**PARTS & SERVICE
NEWS**

REF NO.	AT03227
DATE	Dec. 8, 2003

SUBJECT: MODIFICATION PROCEDURE TO INSTALL YELLOW WARNING LIGHT ON WA100-5 TO WA320-5 CAB (SINGLE OPERATOR)

PURPOSE: To introduce a modification procedure to add the mounting seats for the single operator cab spec. light diffusing revolving lamp and yellow colored revolving warning light onto WA100-5 thru WA320-5 wheel loaders

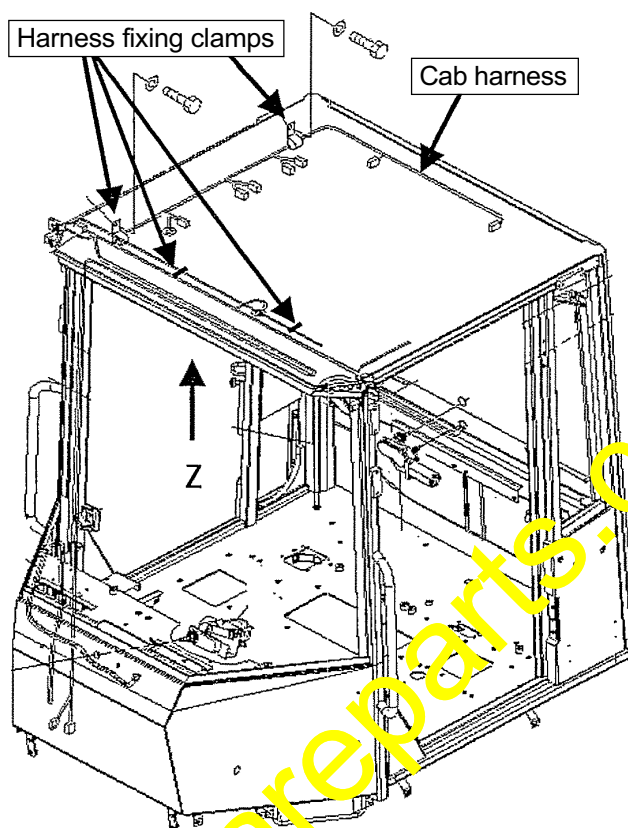
- ① Remove the interior parts (1) thru (7) from the operator's cab.
Since the removed parts, bolts, screws, washers, etc. are being reused when making the restoration work, keep them carefully.
Discard the roof pad fixing buttons.

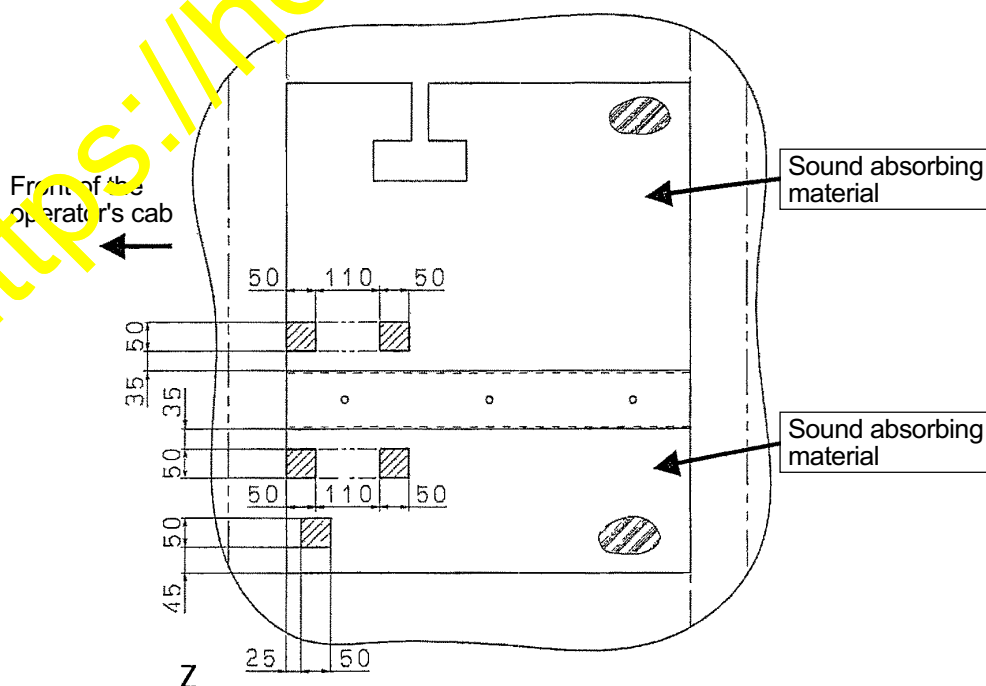
- ② Note) To prevent damage by the welding heat, remove the clamps of the cab harness and keep the cab harness away from the upper surface of the roof.

When viewed from the inside of the operator's cab

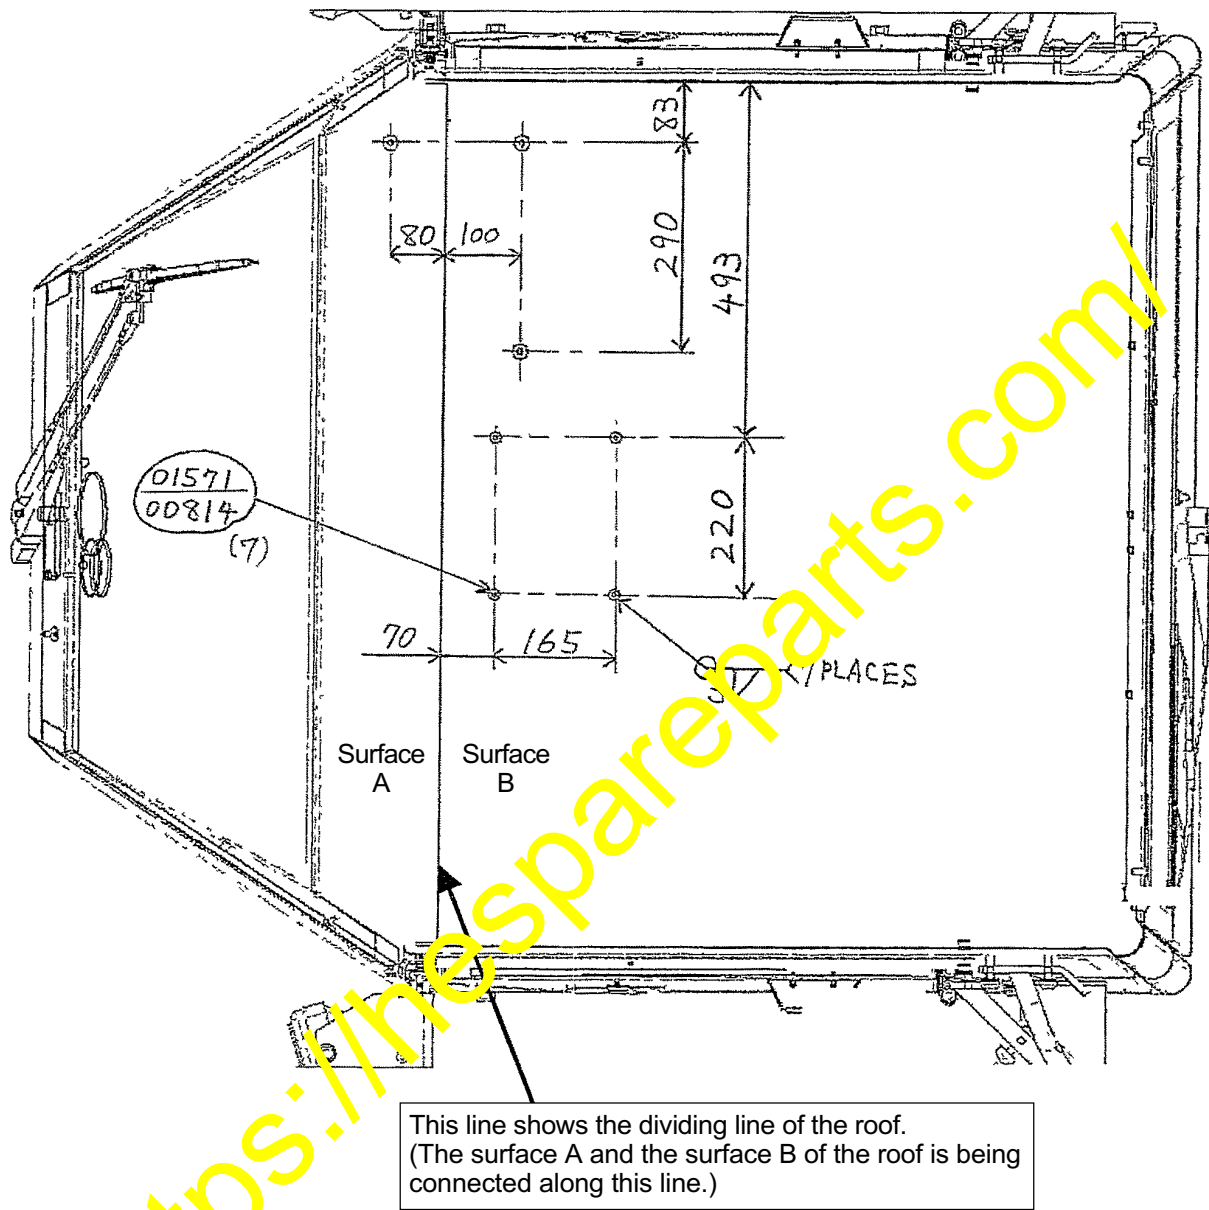
- ③ To prevent influence of the heat generated when welding the seats, cut the sound absorbing material. (The hatched sections at the 5 places shown in the drawing below)

When viewed from the upper side of the roof

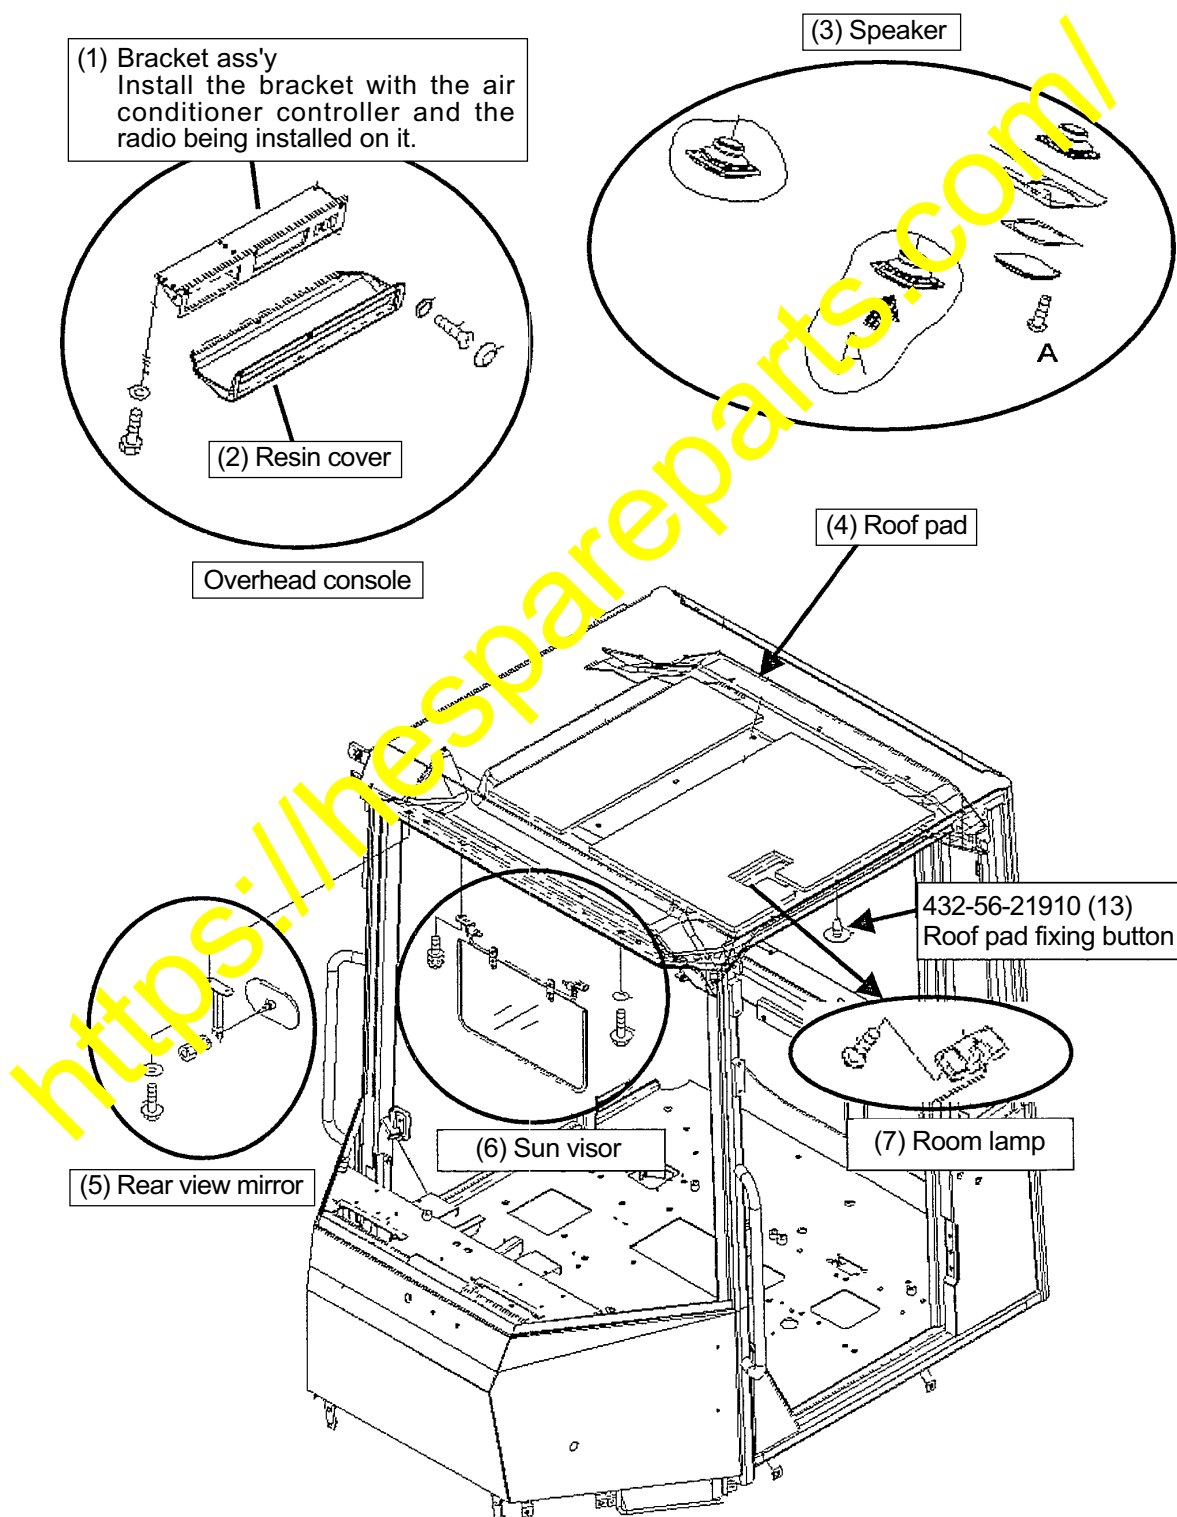
- Weld 7 pcs. of the seats (01571-00814) to the upper surface of the roof.

- After finishing the welding work, apply paint. (Paint color: Natural Yellow)

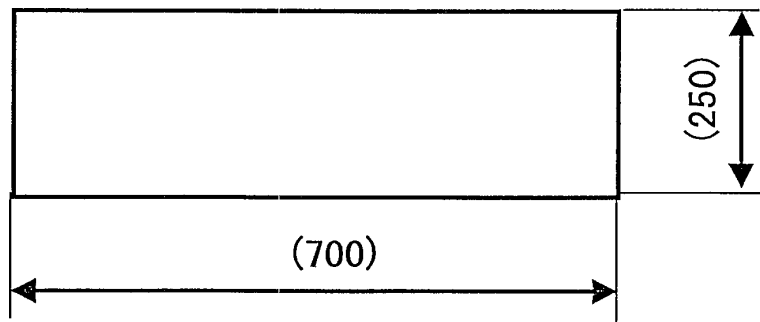
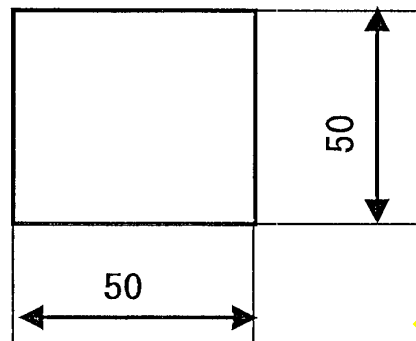
- Cut the sound absorbing material (416-926-3780) to the following dimensions (50 × 50).

- Make out 5 pcs of the cut sound absorbing materials for a machine.

When viewed from the inside of the operator's cab

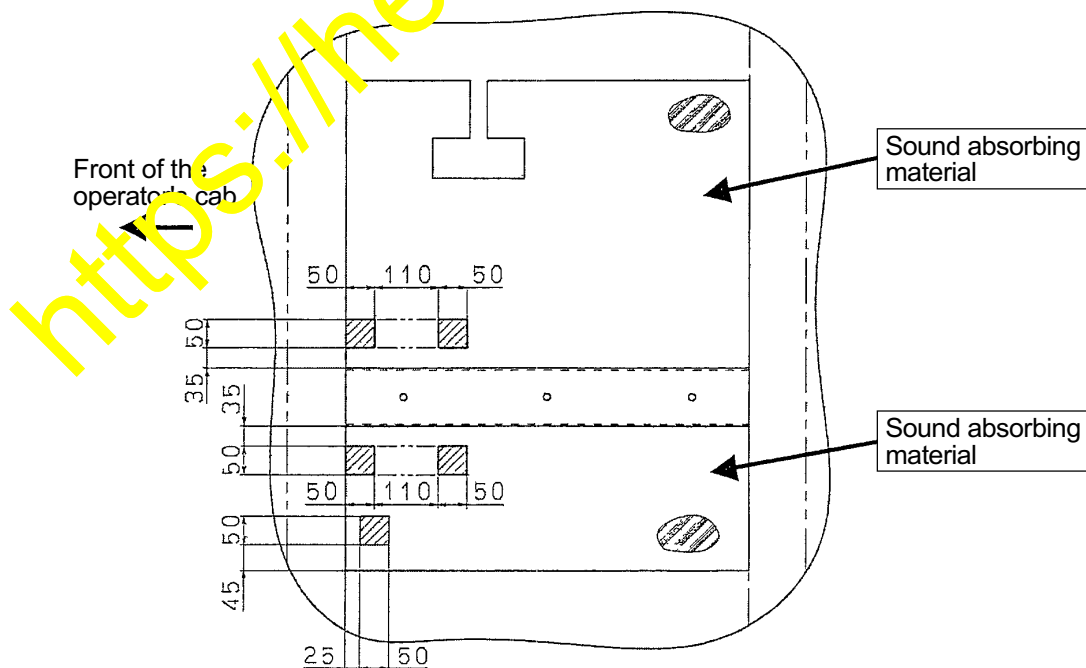
Stick the above parts to the square holes cut in the sound absorbing material as per Section 3-③ (the hatched sections at the 5 places shown in the drawing below).
